## **Lufttüchtigkeitsanweisung/ Sicherheitsmitteilung**

**Nummer:** 01/09+014/2002

**Betreff Flugzeug Typ:** FK9 Mk3 + FK14

**Detail:**  
Höhenrudermassenausgleich + Trimmruder

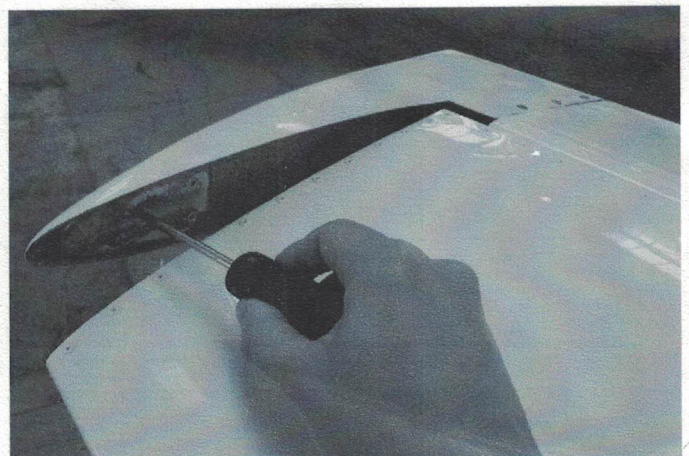
#### **1.trim-tab hinges:**

the hinge axles has to be controlled for proper positioning. Thereafter they have to be secured  
With a drop of colour on their ends!

#### **2.Installation of elevator mass ballance:**

The screws of the counterweights have to be removed and screwed in by adding of two component glue as UHU Plus or similar.
